**VILLAGE OF VOLENTE, TEXAS**

**AGENDA**

A. Discussion and possible action for a request by Ken Beck, on behalf of Thistle Dew Ranch for a Variance in accordance with Village of Volente Code of Ordinances 2009-0-103, Section 9.05.115, (Cut & Fill) to exceed 5' maximum allowed at the location (15502 Mary Street) Lot 1, Thistle Dew Ranch Subdivision, sur 10.23 acres.

**Re: Site Plan Review  
15502 Mary Street**

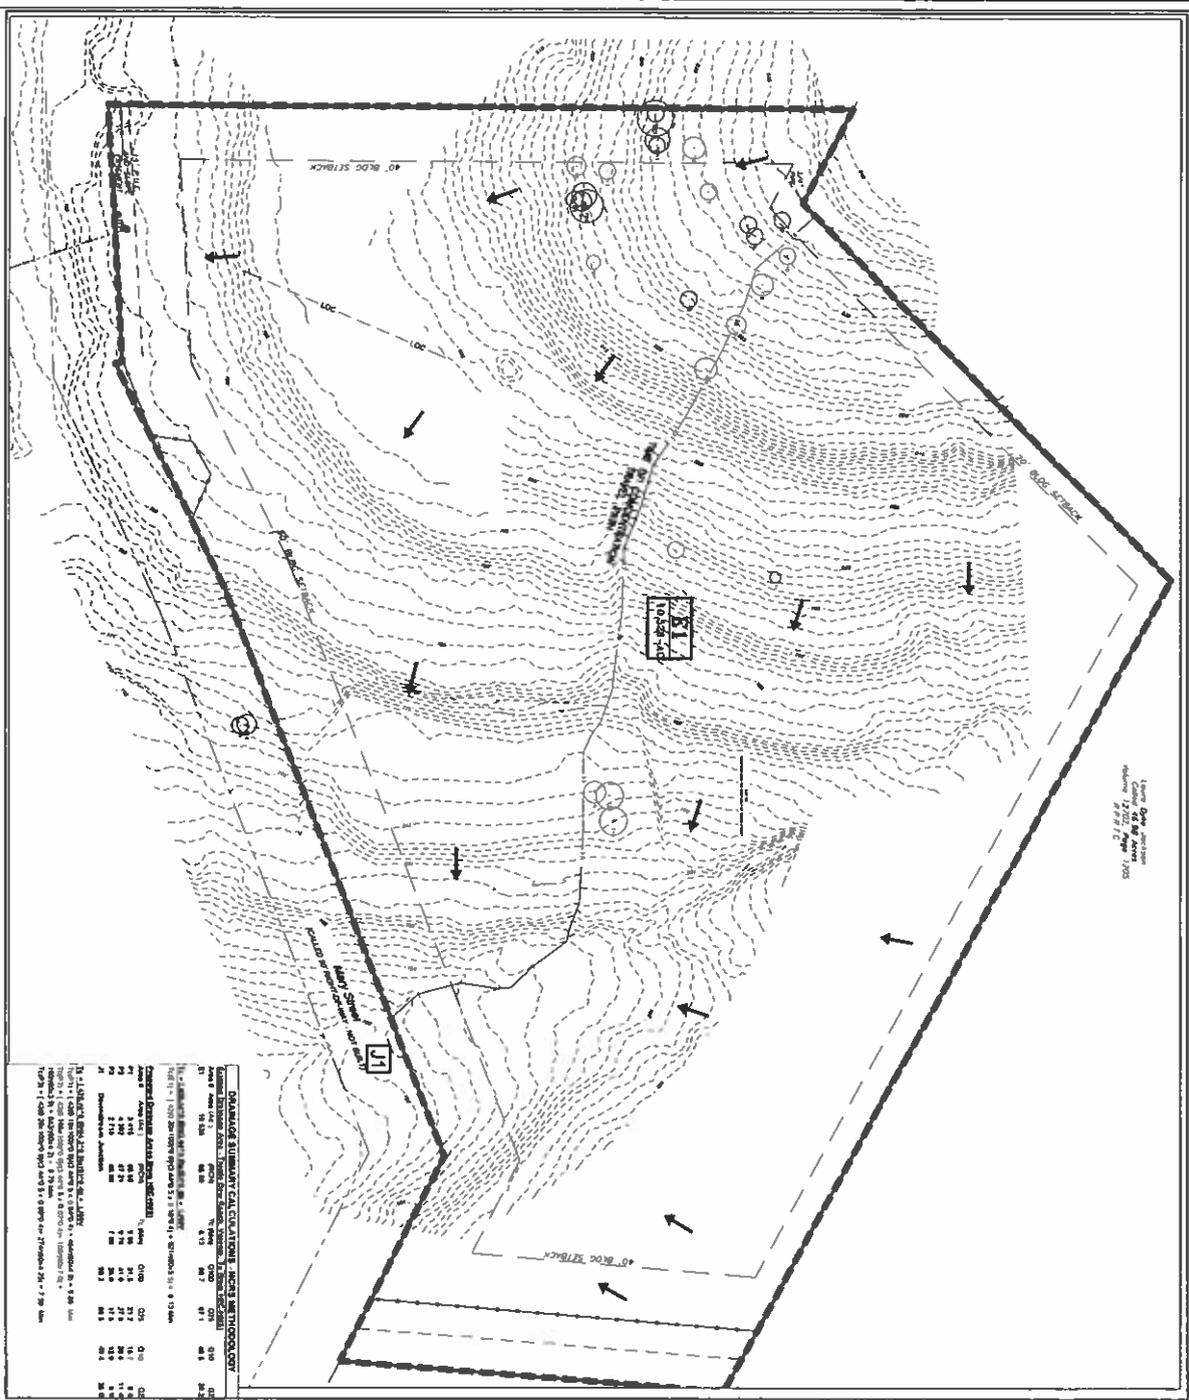
- Please provide a cross-section of the proposed drive located in the ROW.
- Please establish grades for the retaining walls shown on the grading plan. Note: A wall greater than 4-feet from the footing must be designed by a structural engineer. Also, cut and fill greater than 5-feet requires a variance.

- Please show how the grading for the driveway will tie to existing grades, please note: erosion control matting shall be installed on all disturbed areas with a finished grade of four to one (4:1) or steeper.

- The water quality plan states a 3-foot wide and 8-foot deep infiltration stone level spreader. Please provide grading along the level spreader to more clearly define the intent of the design or add another detail to the plan. Walls greater than 4-feet will need to be designed by a structural engineer.

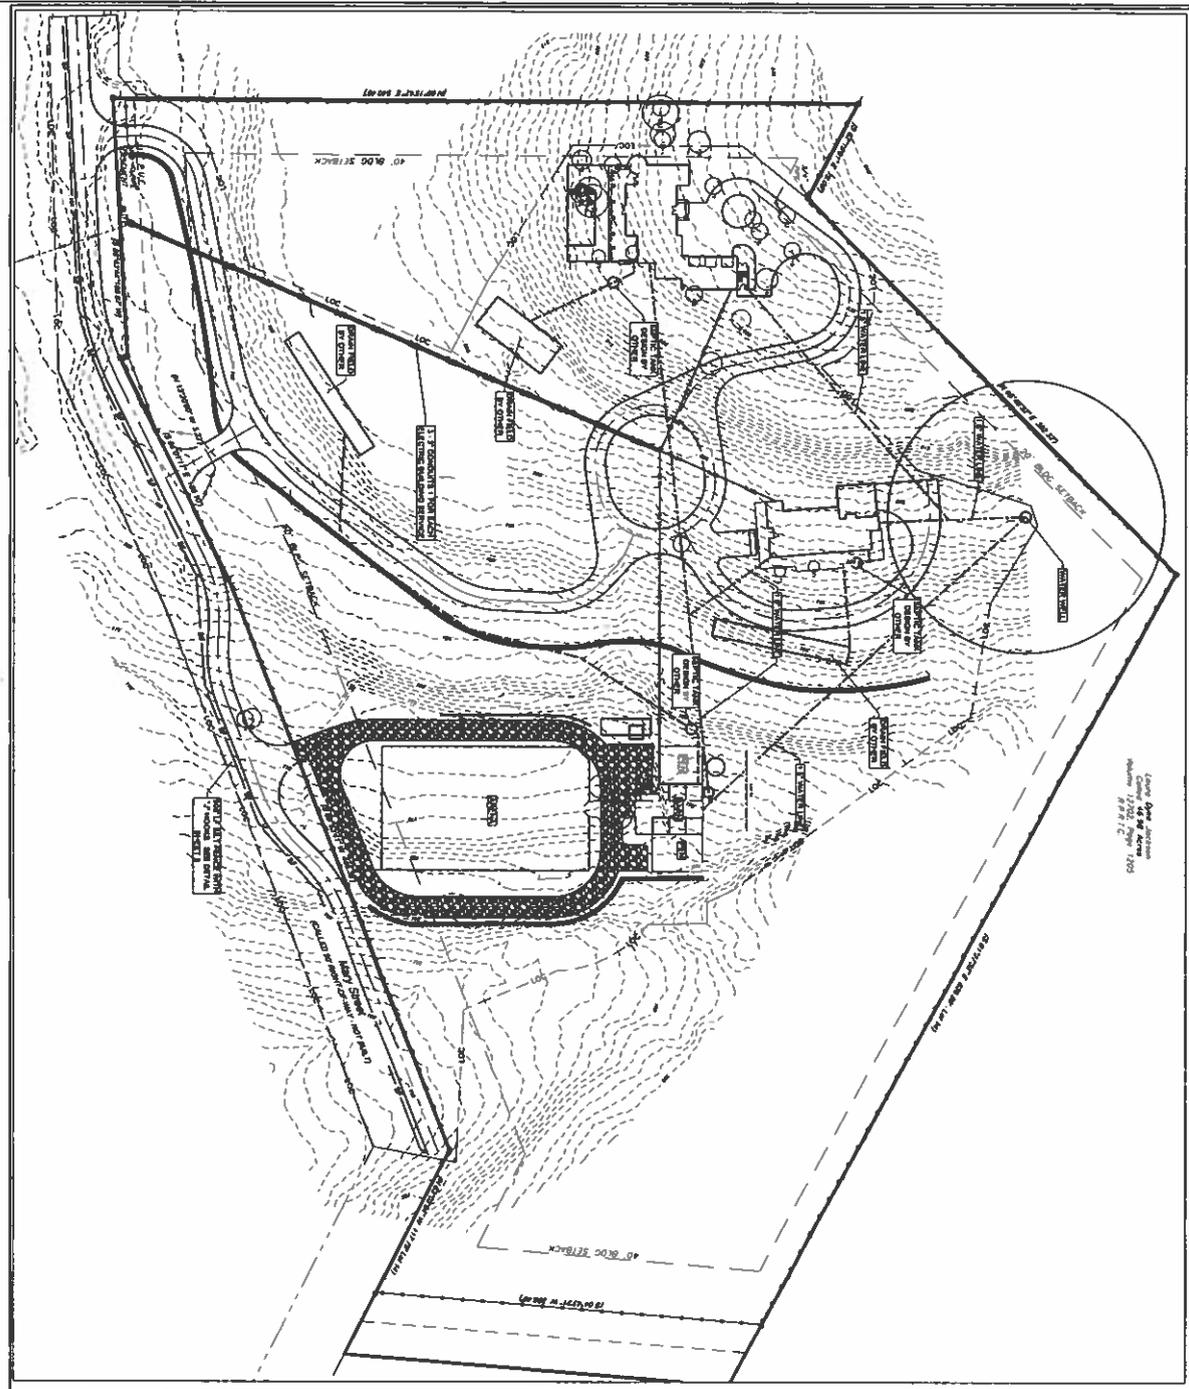
- The P2 drainage area time of concentration (TOC) line makes two 90 degree turns, however the grading plan doesn't reflect any grading changes, please update the TOC and drainage calcs to reflect an accurate flow pattern and flowrate.
